STATE OF NORTH CAROLINA
DEPARTMENT OF TRANSPORTATION

ADDENDUM # 1

Contract No. DN01124
TIP No.: N/A
Federal Aid No.: Helene
WBS Element: DF18314.2044194
County: Haywood
Description: Grading, Drainage, Paving, And Structure: Replace Bridge 430041
On SR 1357 (Crabtree Church Rd) Over Crabtree Creek In Haywood
County

Content Summary: Structures plan sheets revisions, structures special provision revision, and addition of pay item.

REVISIONS				SHEET NO.
NO.	BY:	DATE:	NO.	
1			3	S-1 TOTAL SHEETS 21
2			4

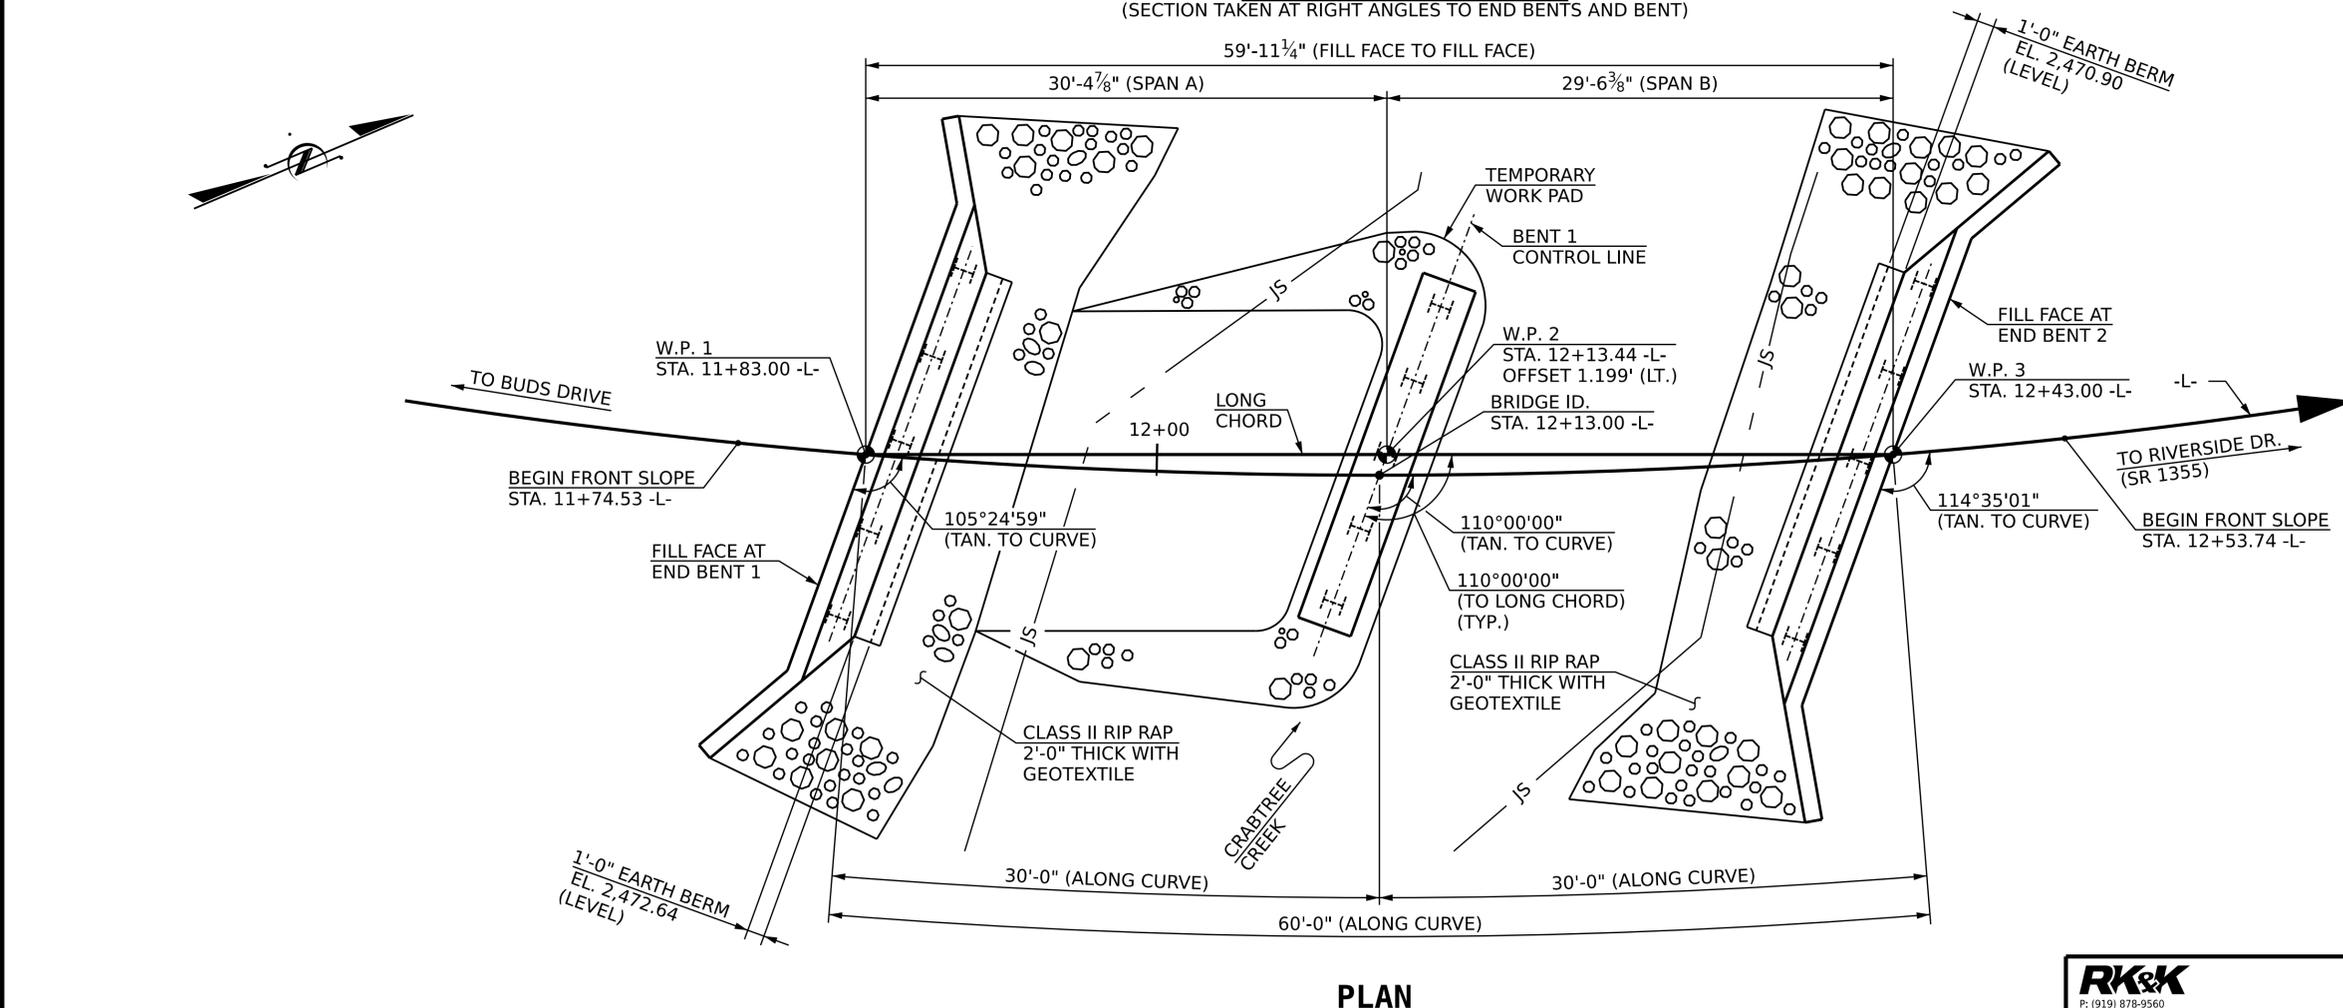
1. On structures plan sheet S-1, work pad to access the interior bents has been added to the plan view. Replace the existing plan sheet with the attached revised plan sheet **S-1**.
2. On structures plan sheet S-5, the pay item for the construction of temp access pay item has been added to the bill of Materials. Replace the existing plan sheet with the attached revised plan sheet **S-5**.
3. The Structures special provisions have been updated to include language regarding the construction, maintenance, and removal of temp access. Replace the existing **Structures Special Provisions**, pages **ST-1 – ST-28**, with the attached revised special provision.
4. Pay item **8017000000-N SP LS, Construction, Maintenance, and Removal of Temp Access at Sta (-L- 12+13.00)** has been added. Replace the existing bid items sheets with the attached.
